SOUTHWEST RESEARCH AND INFORMATION CENTER

October 4, 2021

RE: Class 3 Permit Modification Request (PMR) - Construction and Use of Hazardous
Waste Disposal Units 11 and 12

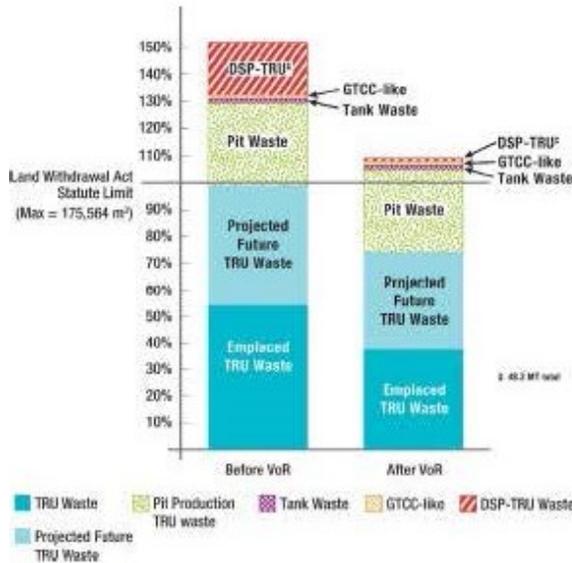
A National Academies (NAS) Committee released the *Review of the Department of Energy’s Plans for Disposal of Surplus Plutonium in the Waste Isolation Pilot Plant* that was issued on April 30, 2020.¹¹ The Committee reviewed in detail DOE’s plans, visited involved sites, and unanimously concluded that those plans would result in the amount of waste at WIPP exceeding the legal capacity – even under the Volume of Record (VOR) calculation.

DOE has not refuted, or even responded to, the NAS Report and its Findings and Recommendations. But clearly, many more than two panels would be needed to accommodate the amount of waste that is included in the Report.

Figure 4: Draft Conceptual Design for Additional Waste Disposal Physical Space at the Waste Isolation Pilot Plant (WIPP)

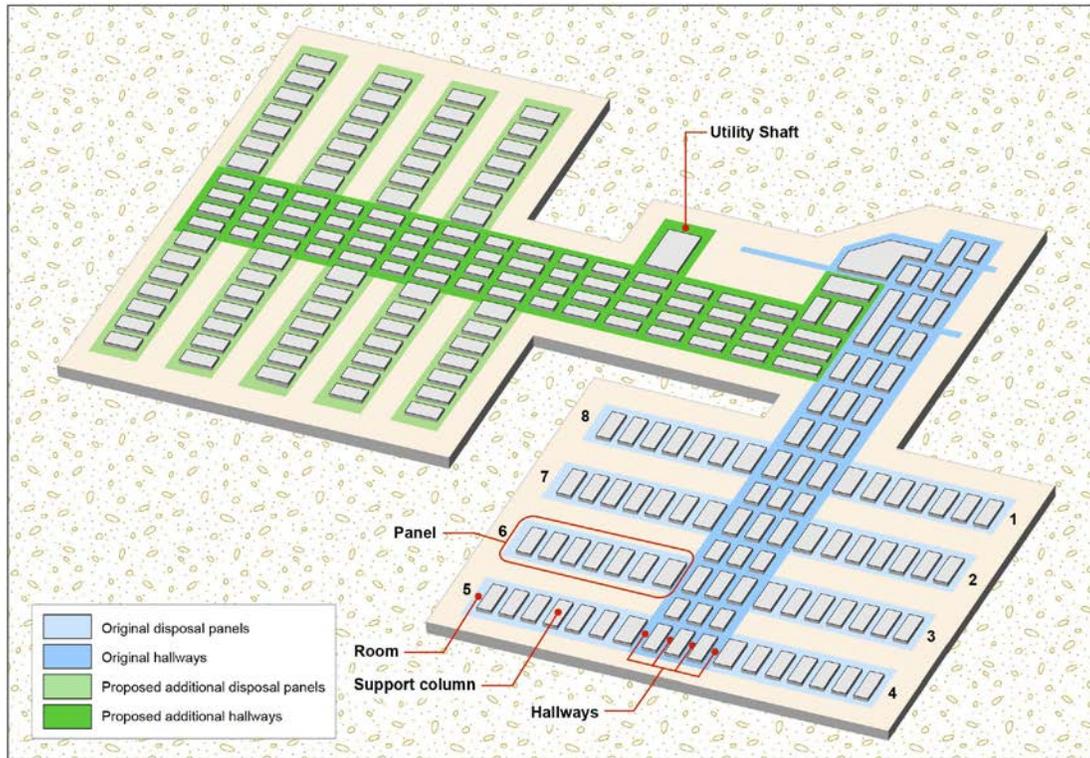
Subsequently, the Government Accountability Office (GAO) issued a report in November 2020.¹² The GAO reported: “During their planning, DOE officials calculated that nine additional panels, using panel designs similar to those of the existing panels, should be sufficient to meet DOE’s TRU waste disposal needs as outlined in its 2018 Annual TRU Waste Inventory Report.” at 18.

Of course, the capacity of nine additional panels would exceed the total amount of waste that will be disposed in Panels 1-10. The GAO report included a conceptual drawing of the nine additional panels.
